Intel Technical Advisory

TA-0959-1

Intel® Server System S7000FC4UR with PBA #D56804-703 may experience an intermittent BMC issue

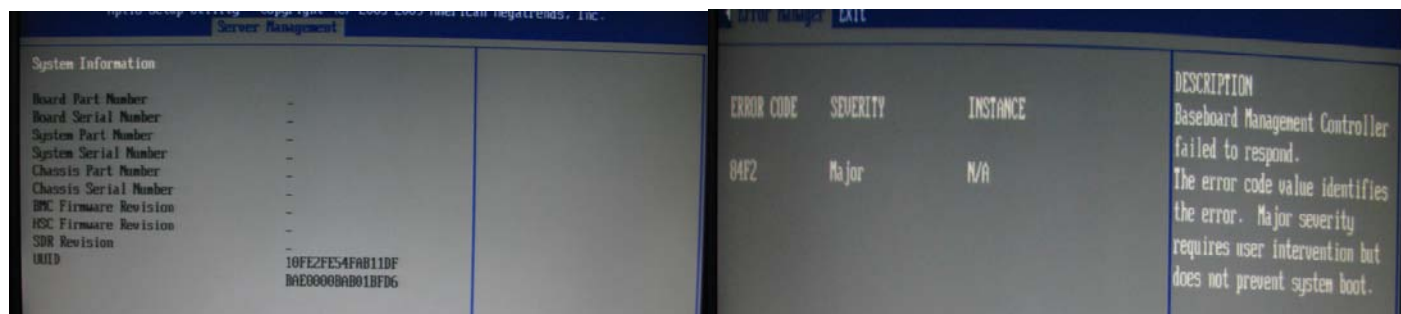
Intel has identified an issue with the BMC on baseboards with PBA #D56804-703. When the issue occurs upon initial AC power on, the status LED does not display the normal yellow/green flashing sequence. The fan speed control is not active and erratic fan control will occur. The system information page of BIOS setup utility is empty and error code "84F2" is logged by the error manager:
